Access Compliance Report

Public Rights-of-Way

Intersection ID: 16439	Main Street: SOUTH_BV	Cross Street: SCALEYBARK_RD	Location: SW
ADA ID: 45EA84B0FEB1	Ramp Type: Perp	Initial Pass/Fail: Fail	Overall Compliance: No
			Severity Score: 21.25

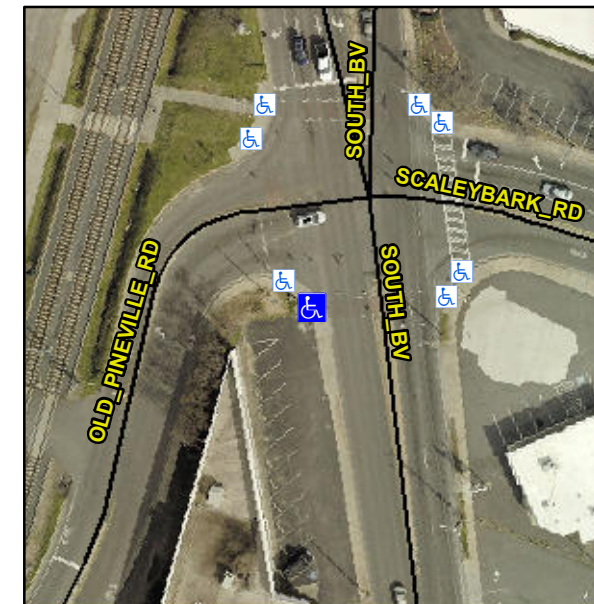
Not Found, R304.5.1, R304.2.2

Compliance	Description	Data	Compliance	Description	Data
N/A	Ramp Length (in)	60.0	No	Ramp Slope (%)	8.9
No	Ramp Width (in)	47.5	Yes	Ramp XSlope (%)	1.0
N/A	Flare Type LT	N/A	N/A	Flare Type RT	N/A
N/A	Flare Slope LT (%)	N/A	N/A	Flare Slope RT (%)	N/A
N/A	Flare Traversable LT?	N/A	N/A	Flare Traversable RT?	N/A
N/A	Landing Length (in)	N/A	N/A	DWS Provided?	N/A
N/A	Landing Width (in)	N/A	N/A	DWS Contrast?	N/A
N/A	Landing Slope (%)	N/A	N/A	DWS Length (in)	N/A
N/A	Landing X Slope (%)	N/A	N/A	DWS Full Width?	N/A
N/A	Landing Curb? (Y/N)	N/A	N/A	DWS Offset (in)	N/A
N/A	Shared Landing?	N/A			
N/A	Gutter Ponding?	N/A	N/A	Gutter Slope (%)	N/A
N/A	Gutter Lip Ht (in)	N/A	N/A	Gutter X Slope (%)	N/A
N/A	Painted X Walk1?	Yes	N/A	Painted X Walk2?	N/A
	X Walk 1 Direction	To E		X Walk 2 Direction	N/A
N/A	X Walk 1 Width (in)	98.0	N/A	X Walk 2 Width (in)	N/A
	X Walk 1 Slope (%)	1.2		X Walk 2 Slope (%)	N/A
	X Walk 1 X Slope (%)	1.1		X Walk 2 X Slope (%)	N/A

Remove & Replace Entire Ramp.
